27 March 2026

**Re: Daylight testing with canopies to Brookleigh School**

*Image 2 - Ground floor plan – Rooms assessed with canopies highlighted in red*

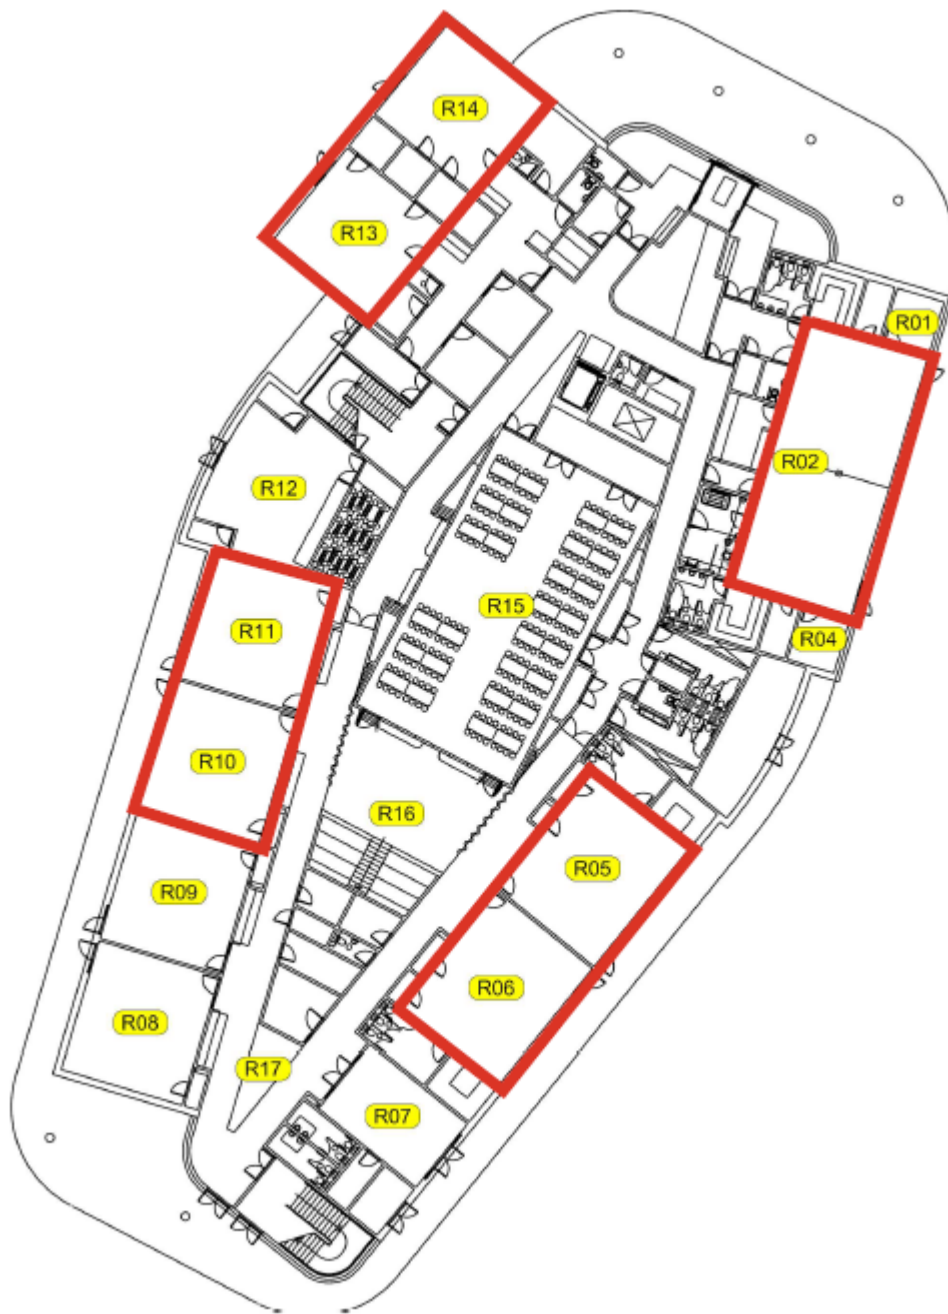
Our analysis indicates that with the opaque canopies in place, all education rooms where the canopies have been attached, fall below the daylight targets set out in Technical Annex 2E. The retained Spatial Daylight Autonomy (sDA) levels with the opaque canopy in place range from 151–214 lux, below the 300-lux requirement. This would leave the overall compliance at 67%, demonstrably below the requirement for 80% of Basic Teaching Spaces to meet compliance, as defined in Output Specification – Technical Annex 2E.

Whilst, the glazed canopy option performs better, with levels between 182–244 lux, all education spaces with the added canopies remain below the target of 300 Lux.

This reduction is expected, as both options act as a direct obstruction to daylight entering the rooms. Whilst the glazed canopies perform better, daylight still has to pass through an additional layer of glazing,

which in turn has its own transmittance value (in this case modelled at 0.68), resulting in a portion of daylight to be reflected before the remaining light reaches the classrooms.

As such, both canopy options would result in material reductions to daylight provision and lead to deviations from the required standards in each room where the canopies are proposed.
